LANDMARKS PRESERVATION COMMISSION

STAFF REPORT

2113 Kittredge Street – California Theater

Structural Alteration Permit (#LMSAP2022-0011) to demolish the California Theater building while retaining and rehabilitating the primary façade, and to incorporate the façade into the construction of a new 18-story, mixed-use building featuring an approximately 24,000-sq. ft. performance venue and 211 dwelling units in the Downtown.

Fig.6 – California Theatre – Recommended window treatment

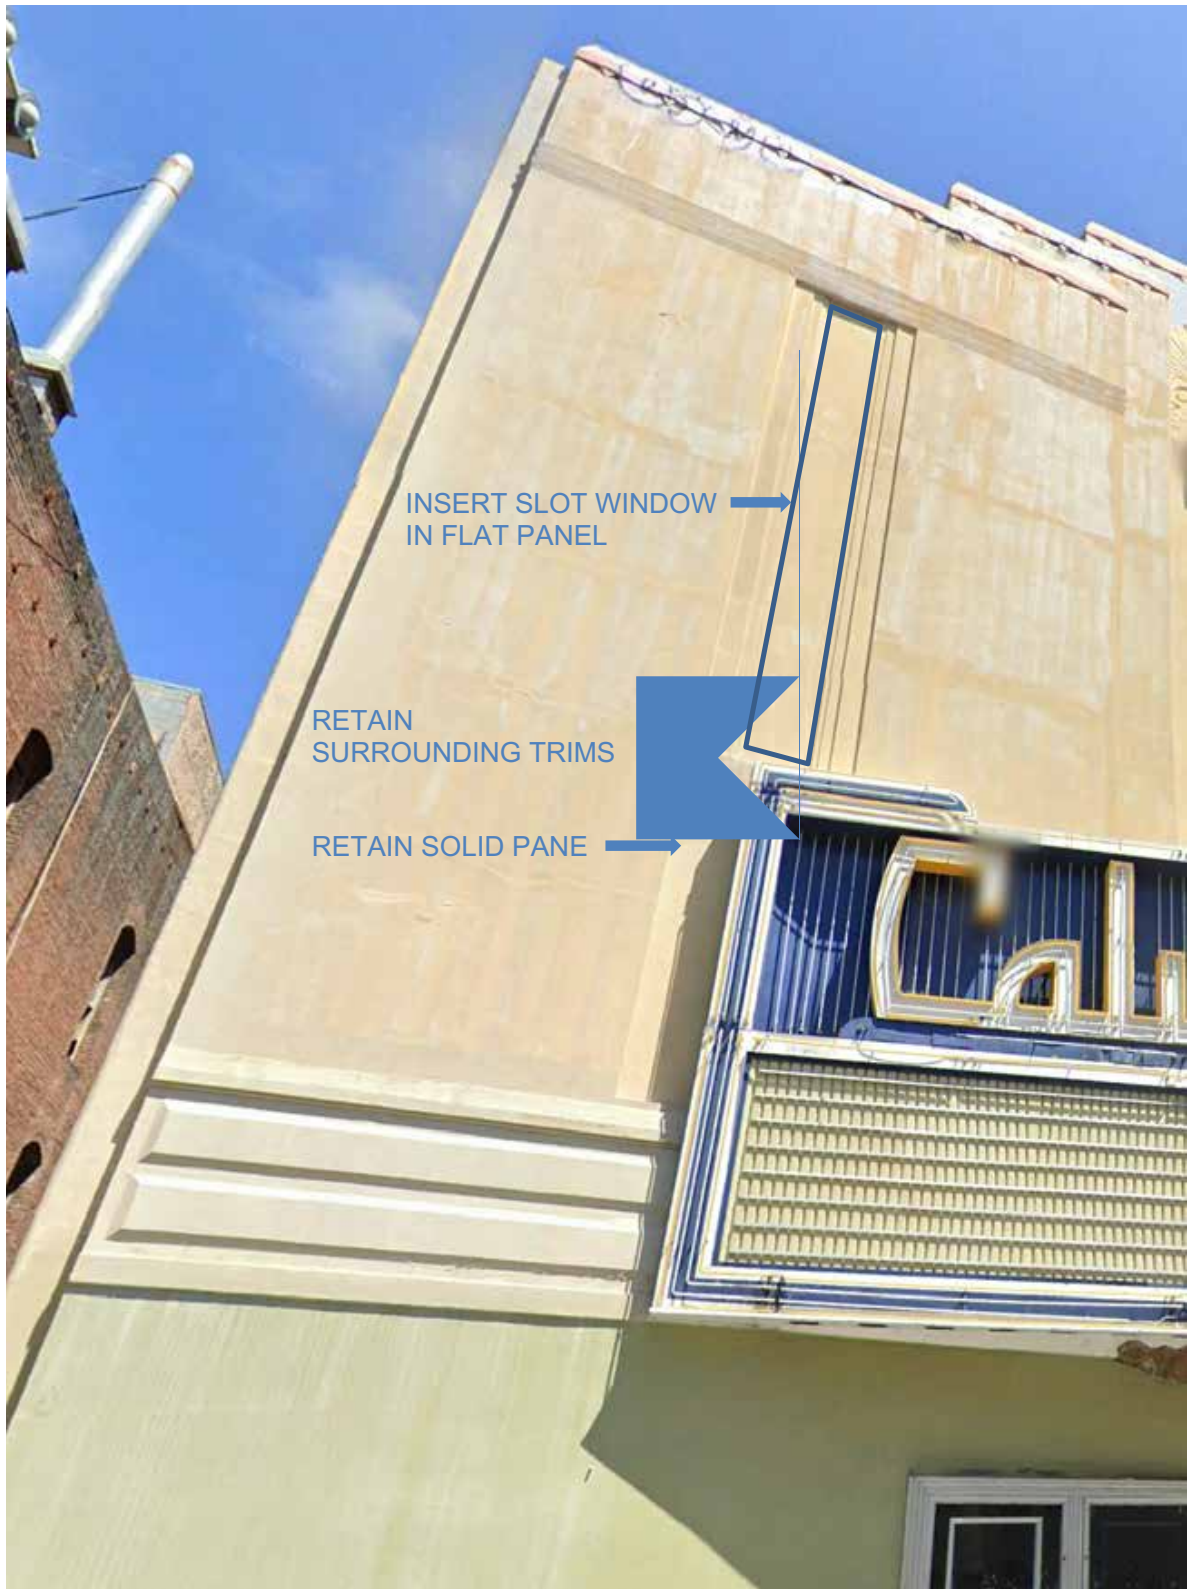
Under standard 9, the primary planning and design concerns are relative scale and proportion. In this case, the proposed project would add a large building not directly above but behind the identified historic building, which historic building is constituted by its 3-dimensional, Art Deco style theater facade and neon marquee and which historic facade has a strong vertical design aspect, counterpointed as well as reinforced by its projecting marquee. The expressive verticality of the 1929-1930 façade design was remarkably illustrated in an ad for the theatre's 1930 reopening (see fig.4). The proposed addition would stand behind and above that historic structure and reflect the historic design, with a vertically oriented center flanked by recessed balcony bays and narrow outer wings.

With the proposed design of the vertical addition, the proposed addition appears to reinforce the verticality of the historic structure not by competing with its grandeur but by amplifying its scale and proportion. This potential effect is best illustrated in a design drawing of proposed façade illumination, where the scale and proportion of the historic structure and its addition coalesce (fig.5). In the course of design review and development, it is this positive reinforcing effect that should be furthered – as the current revisions have done by further recessing the new façade as well as by adding more deeply recessed balconies, altogether creating a more vertically expressed and nuanced design. Based on the existing and historic conditions, the treatment of the proposed sideward windows at the historic façade additionally retains and reinforces the original design.
